I-35E

Parkway Design Concept Recommendation of the Saint Paul City Planning Commission

March 11, 1983

FIGURE 2

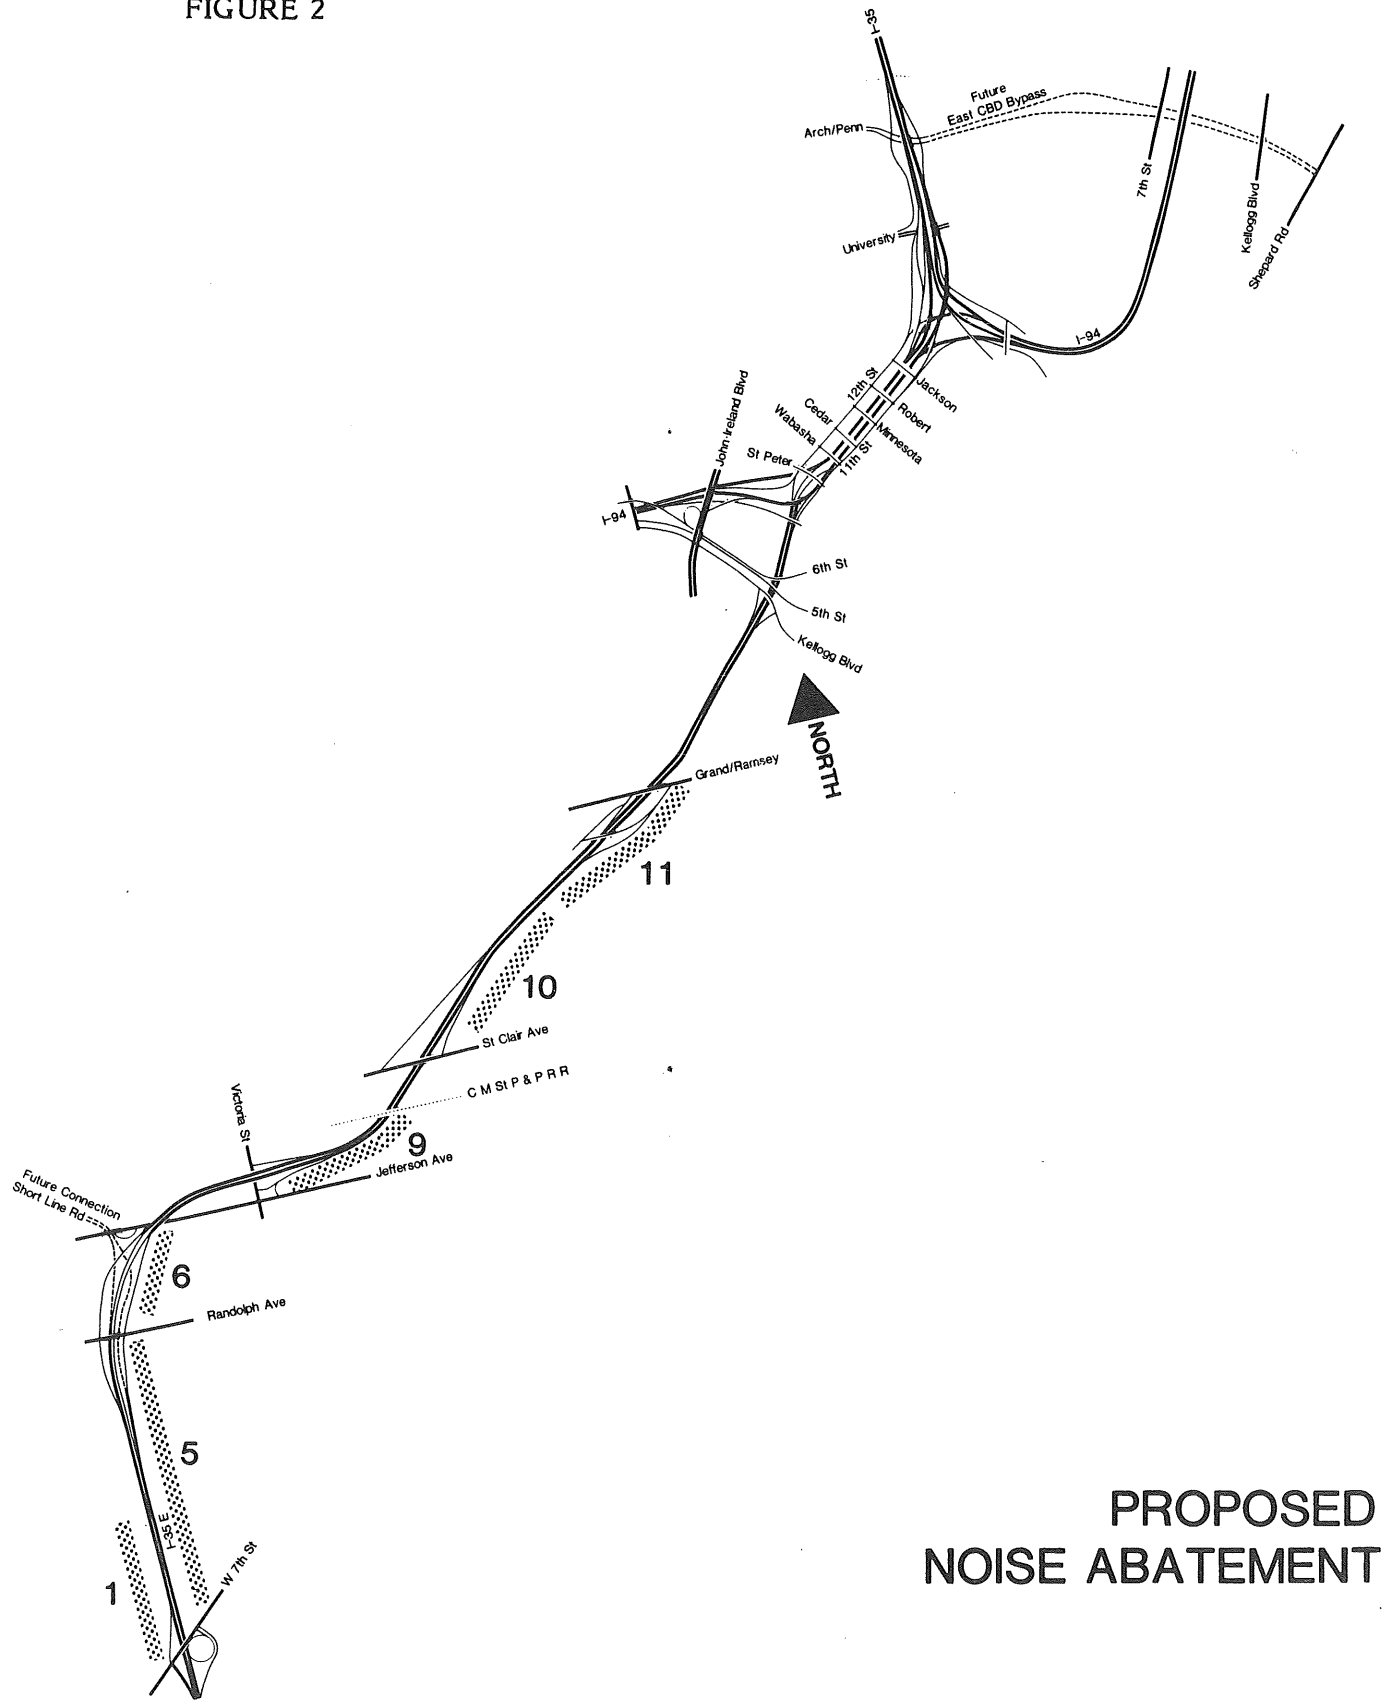
The technical information about noise levels was also presented. Almost everyone who attended the meetings was in favor of the noise walls being built. Some people said they thought higher walls would be more effective.

The reason that five-foot walls are proposed is that heavy trucks are prohibited. The noise sources (tires and exhaust) are much lower on cars than on trucks. MnDOT staff did evaluate the cost-effectiveness of higher noise walls. They found that doubling the height to ten feet would not produce an audible difference in the noise levels at residences. Moreover, federal standards will be maintained in all locations with 5-7 foot walls.

Some residents in the area northeast of the Grand-Ramsey interchange commented that they wanted noise walls (none were proposed there). According to monitoring done for the EIS, the existing noise level near United Hospitals and the Irvine Hill Condominiums is 60 decibels. Predicted levels with the Parkway completed are 59-64 decibels. This is because the expected traffic on the Parkway will not be significantly noisier than existing traffic on Ramsey, Grand and Pleasant. Even the highest predicted noise level is well within federal standards.

The noise walls should be built as proposed.

1. St. Clair Avenue (Figure 5)

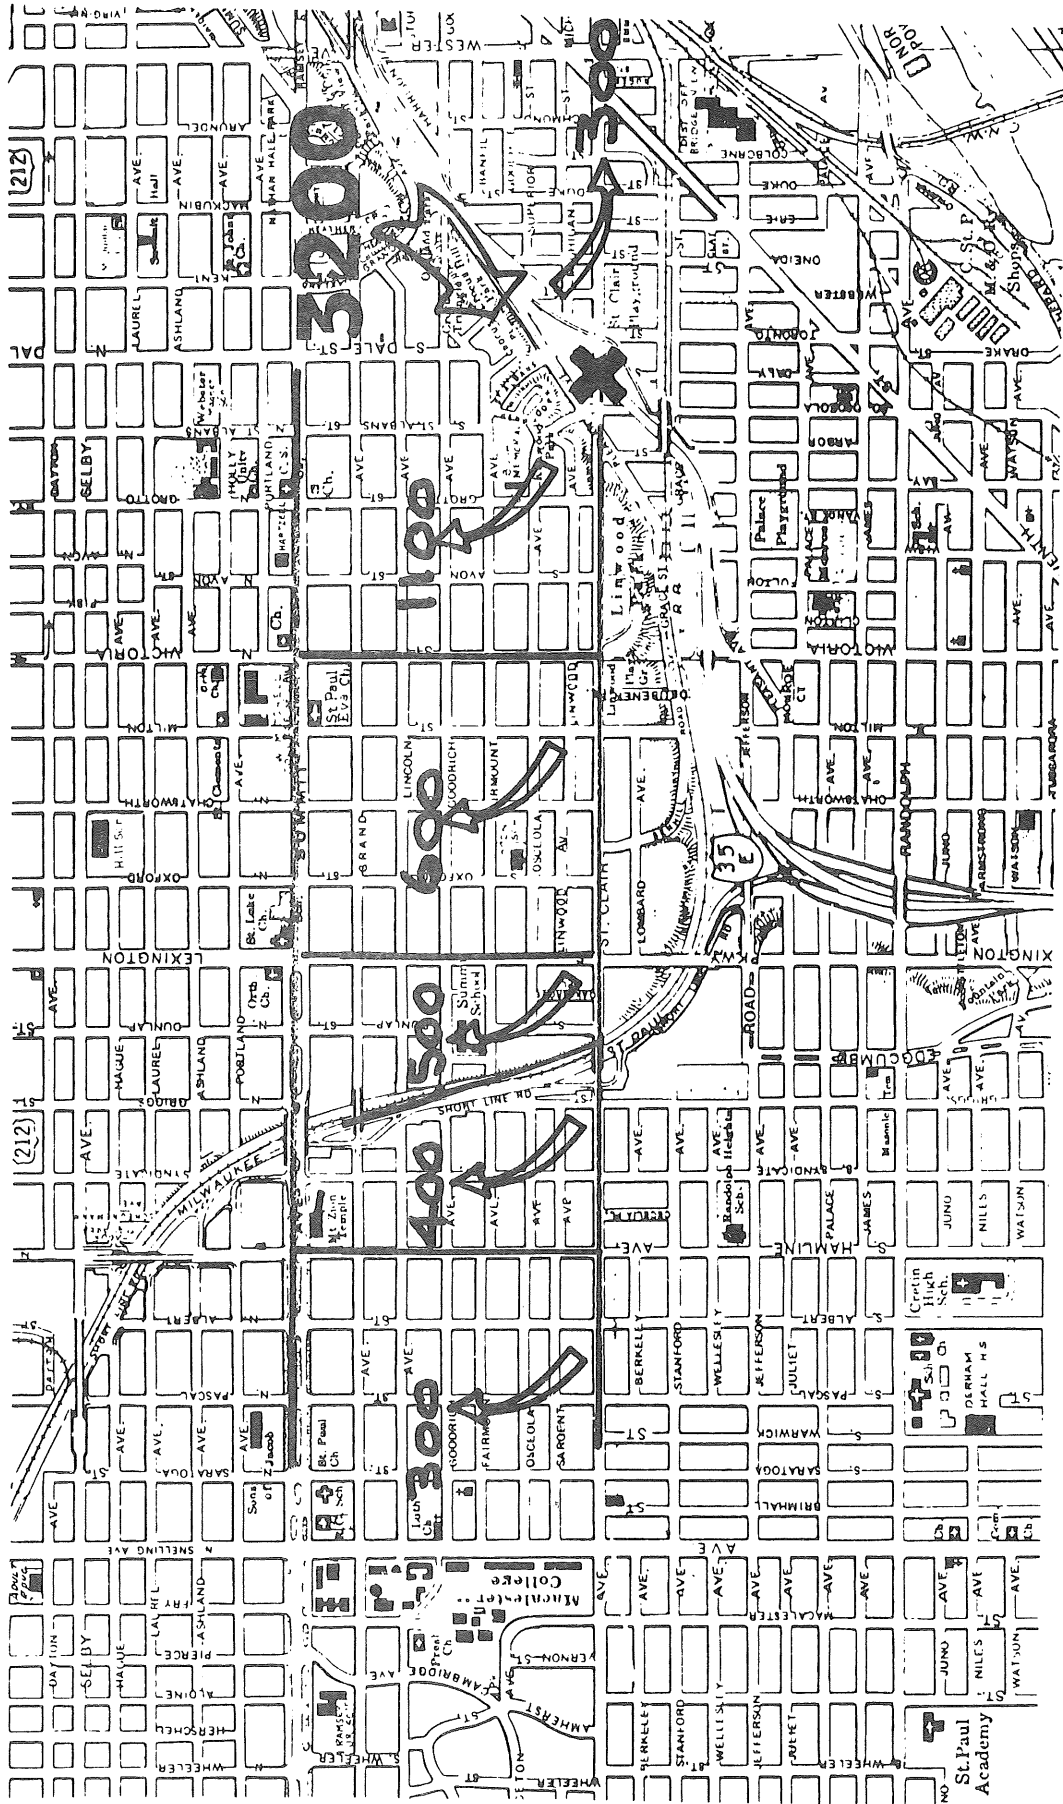
Figure 5 shows the destination distribution by areas. The bulk of the trips using the St. Clair ramps would have a destination east of the Short Line. Also, over 60% of the trips would terminate within one mile of the interchange.

Although the Commission sees no problems resulting from traffic volume shifts on St. Albans, Osceola, Avon, and Victoria, the neighborhood is clearly concerned. Therefore, these streets should be monitored after the Parkway is opened. While the Commission does not believe modifications such as turning these streets into one-way streets is warranted, this option should remain open and can be explored in the future by District 16 working with city staff.

- a. The interchanges at St. Clair, Victoria, and Randolph should be constructed as proposed.
- b. Traffic volume shifts on St. Albans, Osceola, Avon and Victoria should be monitored after the Parkway is opened. The option of creating one-way streets, while not deemed necessary by the Commission, should nevertheless remain open to future consideration by District 16 and the City. The provision of a traffic signal at the intersection of St. Clair and Victoria should also be evaluated by the City in conjunction with District 16.

FIGURE 7

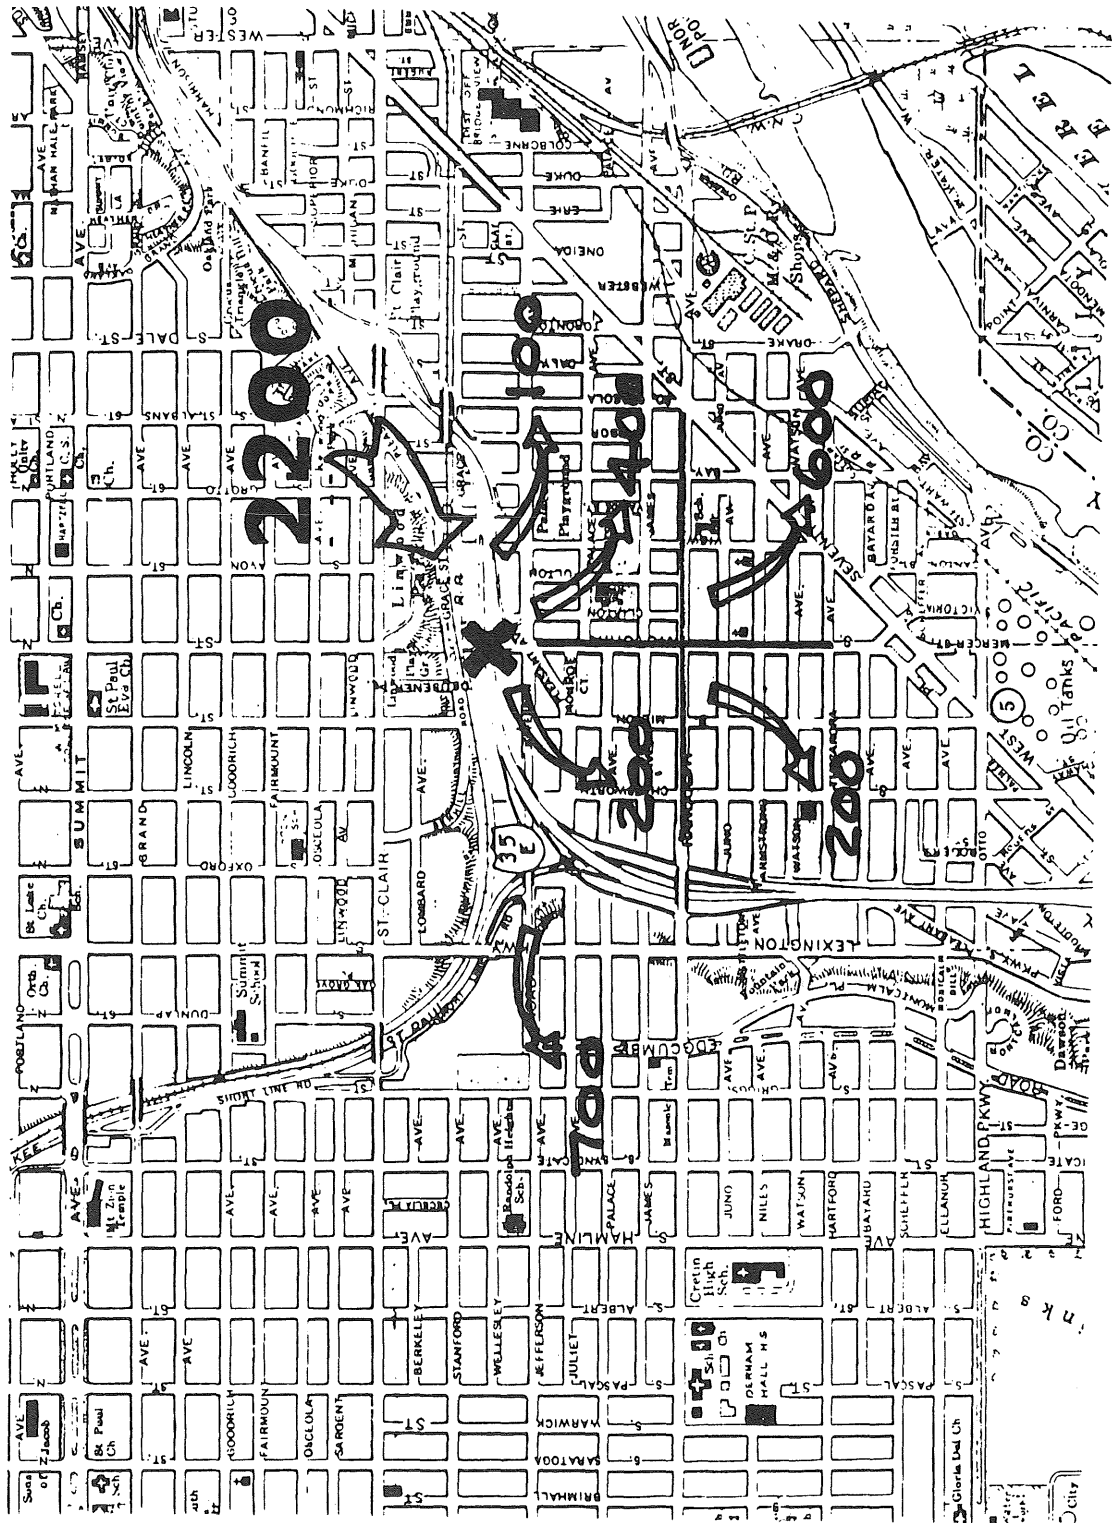
About 2,200 VPD would be expected to use the Victoria Street off-ramp. This volume is also quite low with respect to the ramp capacity. A very few motorists (less than 100) would elect to proceed northbound to the immediate neighborhood near Benhill Road. The number is small and is not shown on Figure 7. Destinations in the Summit Hill area would be more conveniently served by the St. Clair ramp.

As with the St. Clair interchange, the Victoria interchange will produce shifts in local street volumes (Figure 8). Persons living south of the Parkway now must travel north on St. Albans/Dale and Lexington to access I-94 if they desire to go north or east of downtown. Persons desiring to go downtown currently use Jefferson or Randolph to West 7th. With the Victoria interchange, these persons will now use the Parkway. As a result, trips from this neighborhood on Lexington and St. Albans/Dale, Jefferson (east of Victoria), and West 7th will decrease somewhat. Trips on Victoria will increase somewhat. Total trips on Randolph will remain about the same. While downtown oriented traffic on Randolph east of the Parkway will decrease, traffic using Randolph to access I-35E to and from the south will offset this decrease.

FIGURE 10 RANDOLPH AVENUE
NORTHBOUND OFF RAMP DEMAND

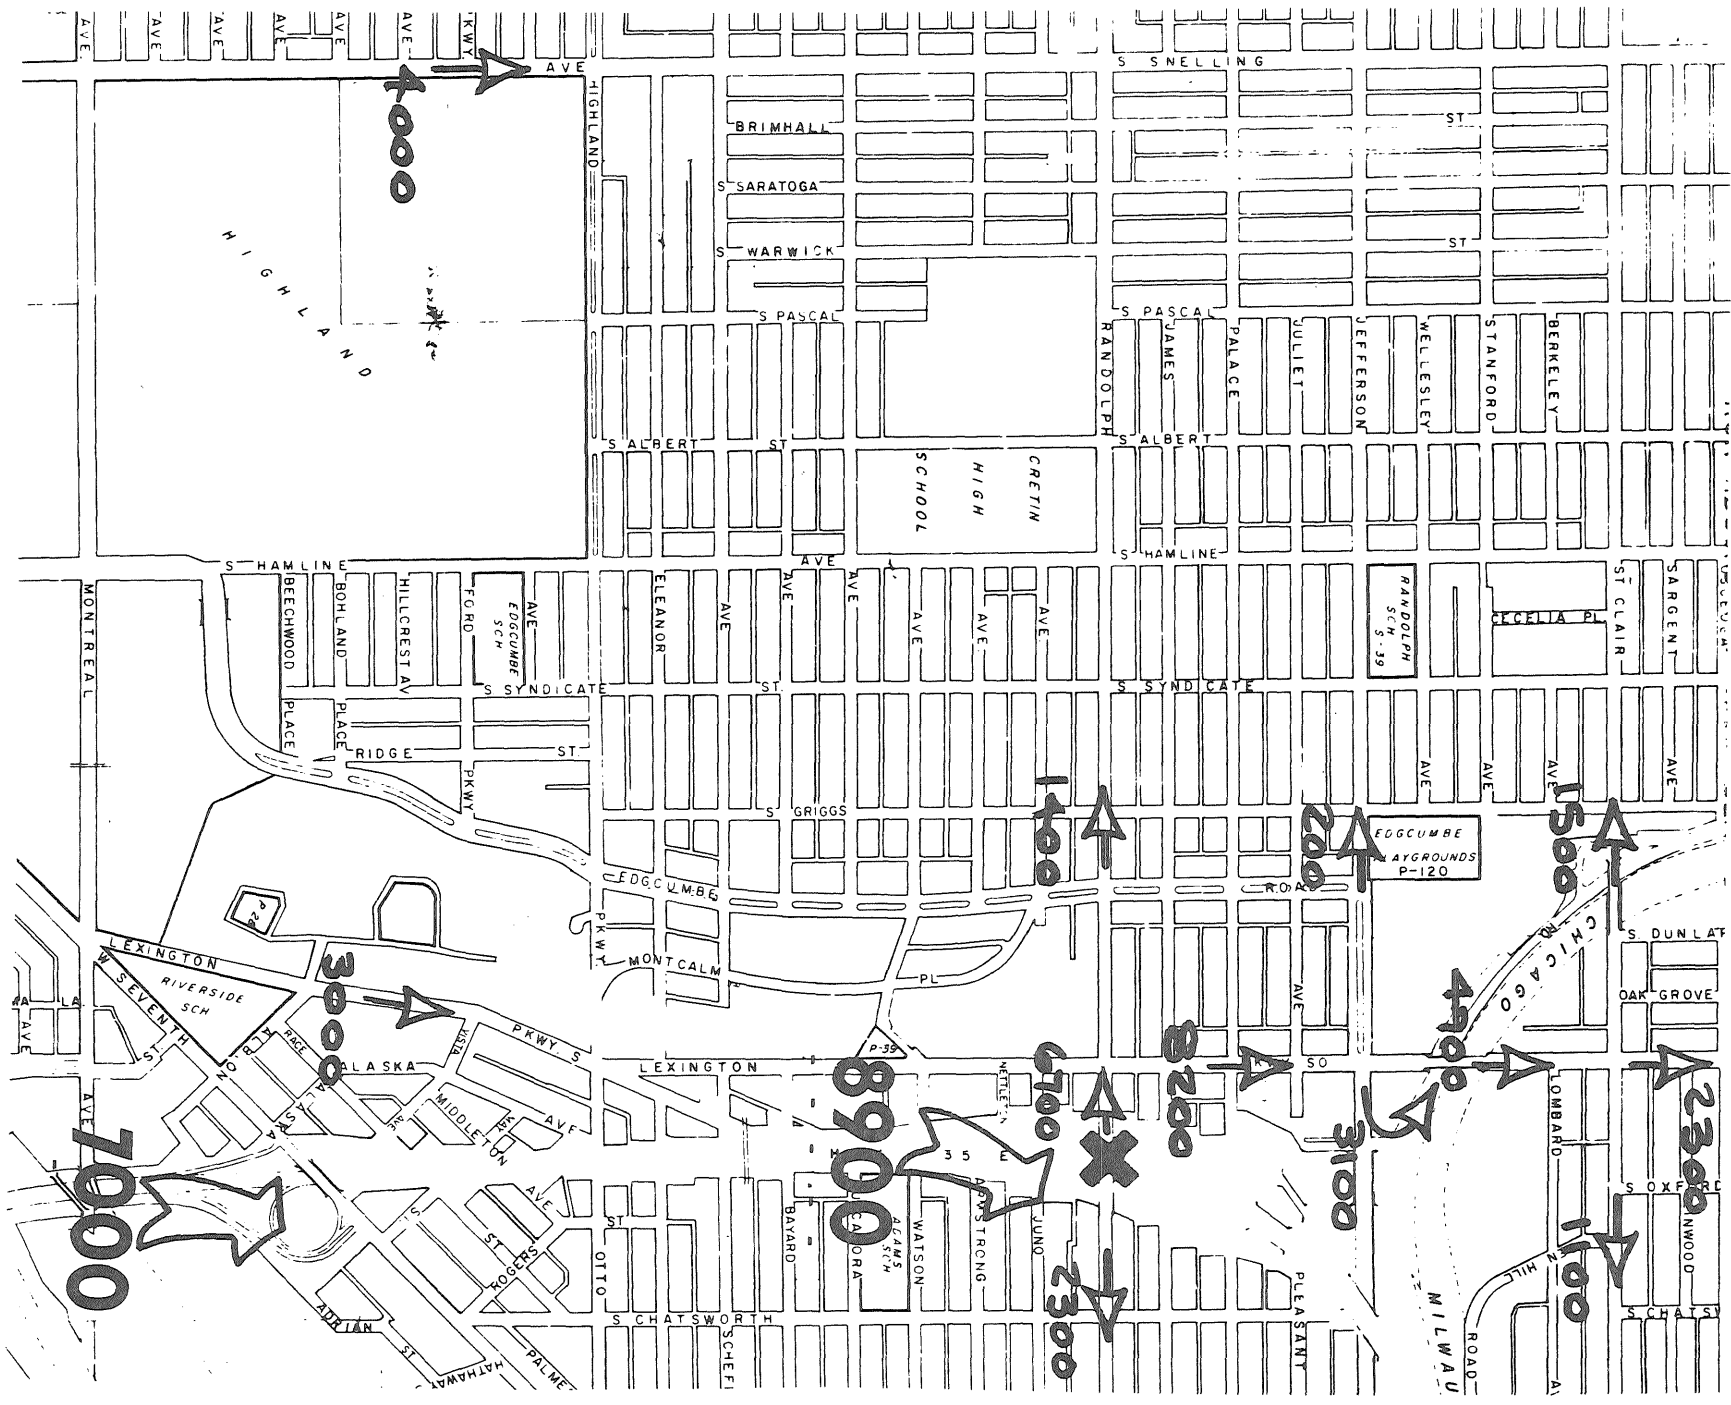
The network used for trip assignments indicates that the demand to use the Randolph northbound off-ramp is 15,900 VPD. This exceeds the ramp capacity. Therefore, many drivers who would desire to exit at Randolph will find an alternate route to avoid congestion and delay. Basically, they will continue to use Lexington Parkway and Snelling Avenue for their north/south trips.

Figure 10 shows that the ramp will probably operate at or near capacity. Approximately 8,900 VPD will exit. The remaining 7,000 VPD of the Randolph demand will elect to exit the Parkway at West Seventh Street. It is important to note that the number 7,000 is not the West Seventh Street exit ramp volume, but only a portion of the total reflecting the over capacity demand from Randolph. Total Seventh Street ramp traffic will be more than 7,000.

The major shifts in local traffic volumes due to this interchange will be in the vicinity of Randolph and Lexington. Traffic volumes today on Randolph between the Parkway and Lexington are 6,200 VPD. This is expected to increase to approximately 20,000 VPD due to north-south travel that will use Randolph and Lexington as an indirect connection between the Parkway and the Short Line. To handle this traffic increase and the turning movements, the signal at Lexington and Randolph will need to be modified to a three phase cycle. Parking on Randolph between the Parkway and Lexington will need to be prohibited.

- c. The traffic signal at Randolph and Lexington should be modified to accommodate anticipated traffic increases.
- d. Parking on Randolph between the Parkway and Lexington should be banned.

4. The traffic signal at Randolph and Lexington should be modified to accommodate anticipated traffic increases, and turning movements. Parking on Randolph between the Parkway and Lexington should be banned.
